INTENDED ALTERATIONS IN THE INTERIOR

Westminster Abbey.

A CLERGYMAN OF THE CHURCH OF ENGLAND.

1844.

Westminster Abbey
Ground Plan.

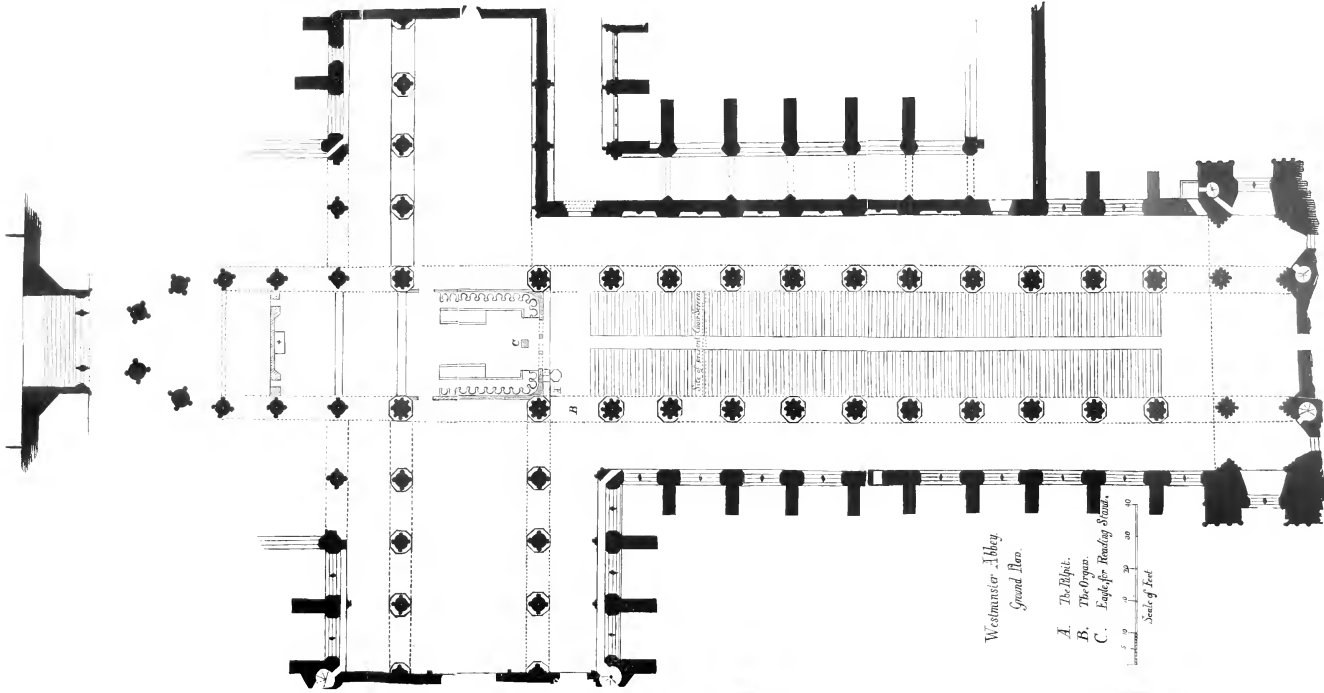
The friend to whose kindness I am indebted for the Plan, has drawn the stalls *in front* of the piers, instead of *between* them, as suggested in p. 12.

2. Those in the transepts, who are at all removed from the line of the present choir, will be quite unable to see the clergyman, either during the prayers, the lessons, or the communion service. A glance at the annexed plan will at once show this, and make it evident that a person standing at all far back in the transepts, will be quite unable to obtain a view of the place (near the second pier from the transept) whence the prayers and lessons are now read, or of the altar. Now without attaching undue importance to the congregation seeing the officiating minister, still it cannot be denied that the being within sight of the clergyman tends to fix the attention to the prayers which he says, or the Scripture which he reads; and,

admitted to the services of the Church. To effect this, I venture to suggest that the present screen at the west-end of the choir should be removed, that the organ should be placed (as at Winchester) on the north side of the church, that the stalls should be carried more towards the east, and that the whole space of the nave, extending from the tower or cross of the transepts to the west door, should be fitted with open seats for the accommodation of worshippers. I think no one will doubt that if this plan be feasible (as I hope to show it is), it will render the appearance of the church yet more majestic and beautiful than it is at present: it is, indeed, impossible to fully realize the grandeur of the *coup d'œil* from the nave to the altar, or the exquisite beauty of the long line of pillars and aisles that would then be disclosed, unbroken by the organ, or the present screen and heavy wood-work which sustains it.

choir, and would therefore be distinctly heard over all the church, and that would assist the attention, and enable the more distant worshippers to follow the clergyman at the altar. And as it is suggested that the pulpit (A) should remain nearly in its present position, which will then be at the junction of the choir and nave, there is no doubt that the preacher would be heard distinctly in every part of the church ; more distinctly, indeed, perhaps, than he is now, surrounded by the wooden screen and stall-work. In fact, it seems impossible quite to estimate the power the voice would have if these obstacles, which now so much hamper it, were removed ; and moreover, as the people would be then more equally spread over the whole church, it is probable that a large congregation would not have the effect of deadening the sound of the voice, as they have at present, when crowded together *en masse* round the officiating clergyman.
